RE: UF-656 Landscape Master Plan Implementation – Tree Mitigation Update, NE Gateway

Specific Information Regarding Additional Tree Removals

REPORT TO THE LAKES VEGETATION AND LANDSCAPING COMMITTEE

PROJECT:
UF-671, Harn Museum American Art Wing

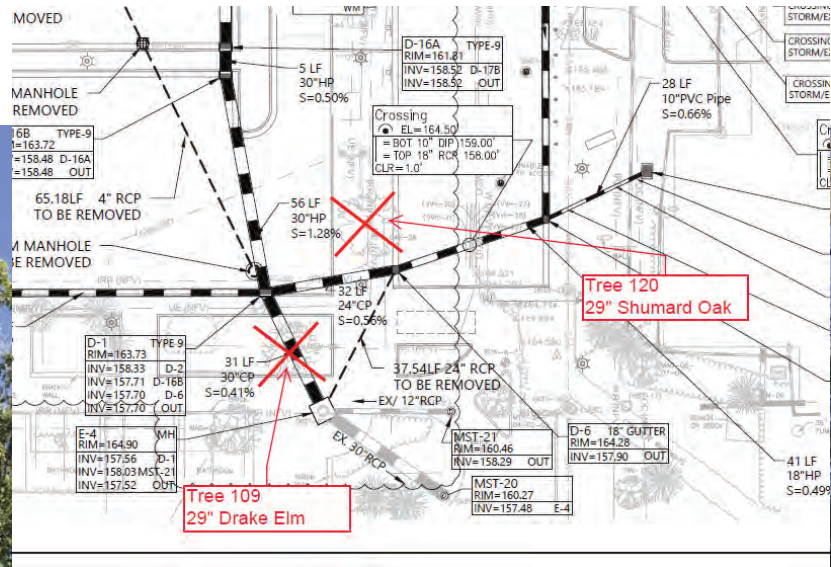
5. Additional Tree Removals, Tree 232: 21" Sabal Palm, Tree 233: 17.5" Loblolly Pine, and Tree 234: 16" Sabal Palm:

These trees are within a cluster behind a low landscape wall at the southwestern corner of Union Rd. and 13th Street. Their location conflicts with the footing of the proposed gateway wall feature.

- Mitigation Addition: Removal of these trees adds 6 replacement trees to the project's mitigation total.

Tree No. 120
29" Shumard Oak

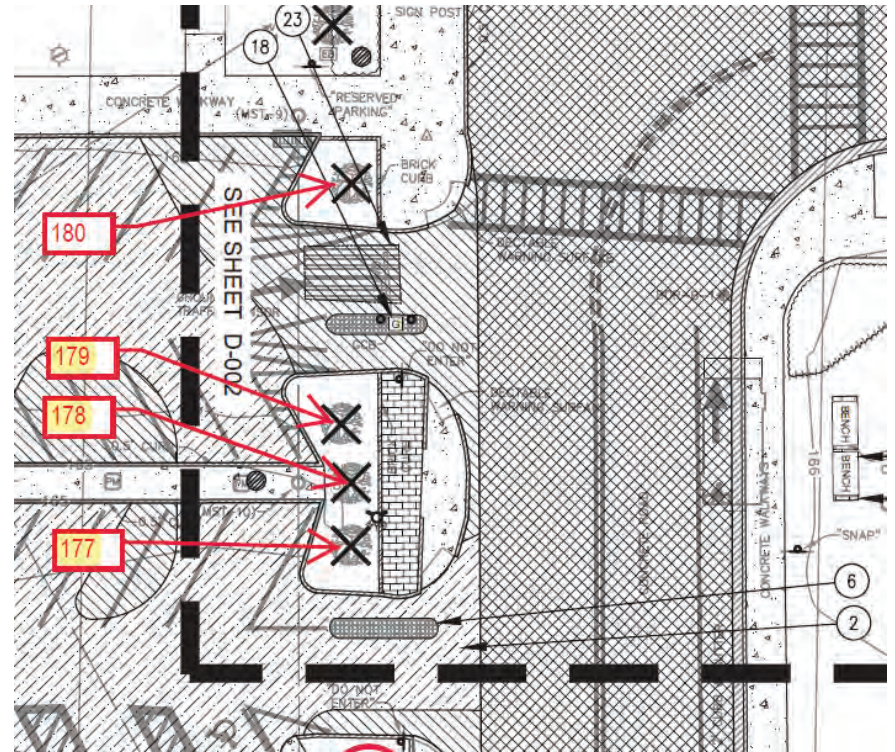
2. Additional Tree Removal, Tree 120, 29" Shumard Oak

This tree is in an existing parking lot end island in the southeastern corner of the existing Little Hall parking lot. This tree has been protected throughout construction to date, but it is within an area of significant Phase 1 infrastructure and paving improvements. UF Facilities Grounds has recently trimmed this tree's canopy for construction equipment access. Proposed Phase 2 stormwater and paving improvements will impact additional, currently undisturbed areas of this tree's root zone. When proposed Phase 2 improvements were generally reviewed with UF Facilities Grounds on site, their recommendation was to remove this tree due to concerns about future decline and then need to remove within the newly installed project.

- Mitigation Addition: This tree is of heritage size and requires additional mitigation. Removal of this tree would add a 7 replacement trees to the project's mitigation total.

Tree No.s 177 - 179
Three 5" Bald Cypress

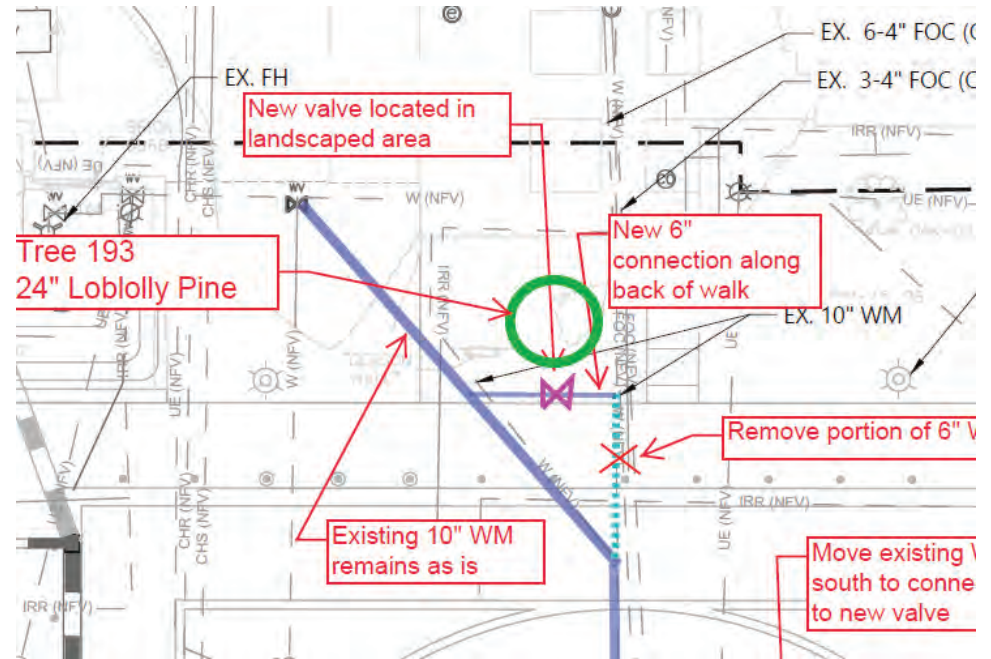
3. Additional Tree Removal, Trees 177 – 179, Bald Cypress, all 5" DBH:

These three trees are in an existing parking lot end island at the eastern end of the Criser Hall parking lot. This project intended on relocating these three trees. However, there is an existing fire waterline located below these trees, and the existing planting area is relatively small and surrounded by paving. These two issues make it impossible to utilize a tree spade to remove these trees, and it is not feasible to remove by hand. A new fire hydrant is also proposed within this island.

- Mitigation Addition: Removal of this tree adds 6 replacement trees to the project's mitigation total.

Tree No. 193
24" Loblolly Pine

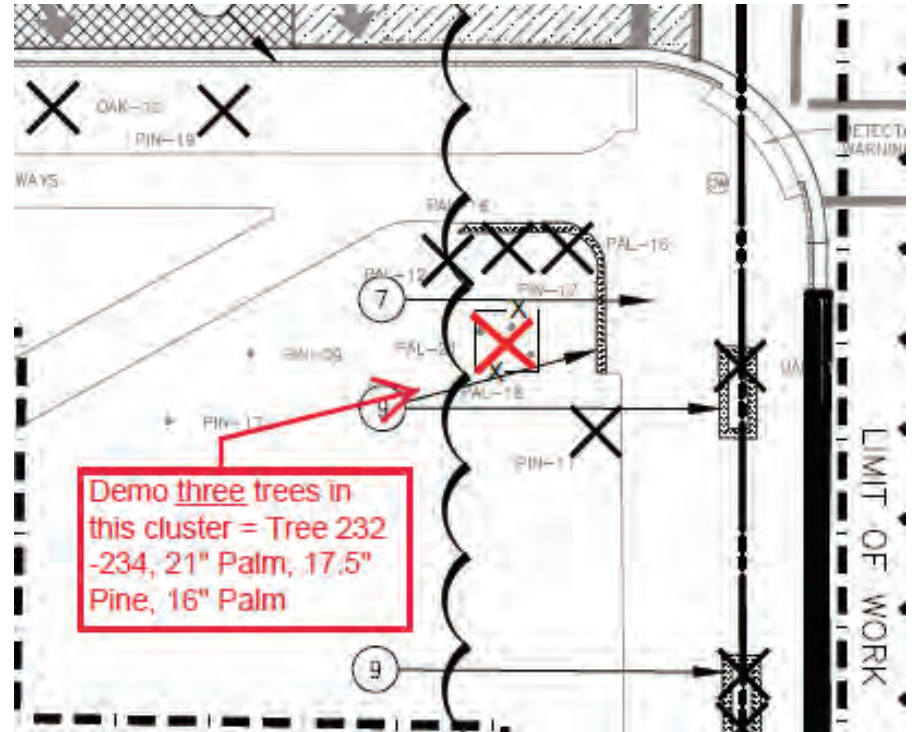
4. Additional Tree Removal, Tree 193, 24" Loblolly Pine:

This tree is located near the southwestern corner of Gerson Hall, along the northern edge of this project. Existing water lines near this tree need to be reconfigured for a number of unavoidable reasons. This utility work will impact this tree's root zone significantly. The tree's existing condition indicates previous impacts to its canopy, so there is additional concern about this tree's resiliency.

- Mitigation Addition: Removal of this tree adds 2 replacement trees to the project's mitigation total.

Tree 264
14" DD Blanchard Magnolia

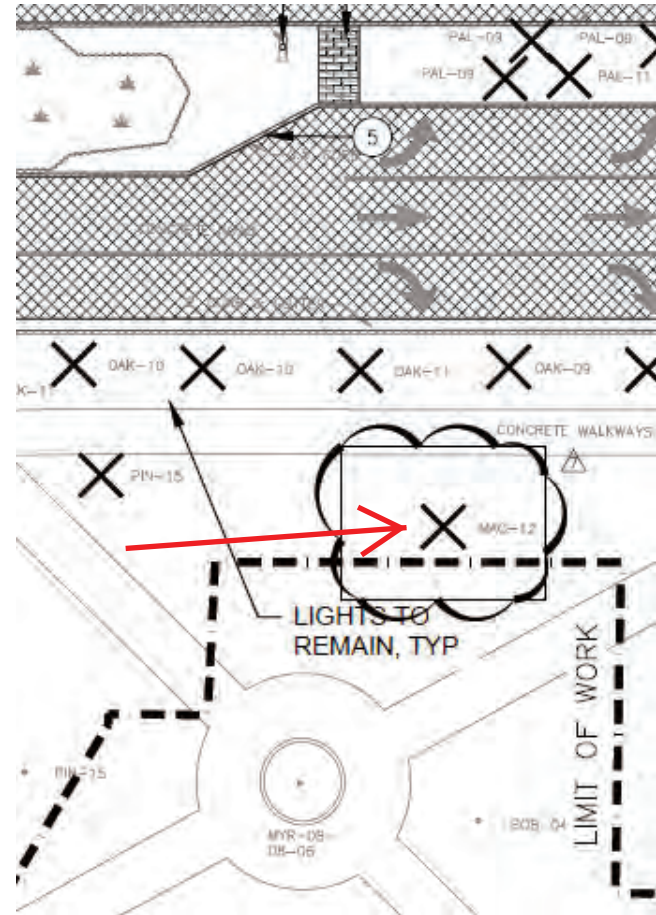
6. Additional Tree Removal, Tree 264: 14" D.D. Blanchard Magnolia:

This tree was located north of Tigert Hall and has been removed. Its location conflicted with proposed walk improvements.

- Mitigation Addition: Removal of this tree adds 2 replacement trees to the project's mitigation total.
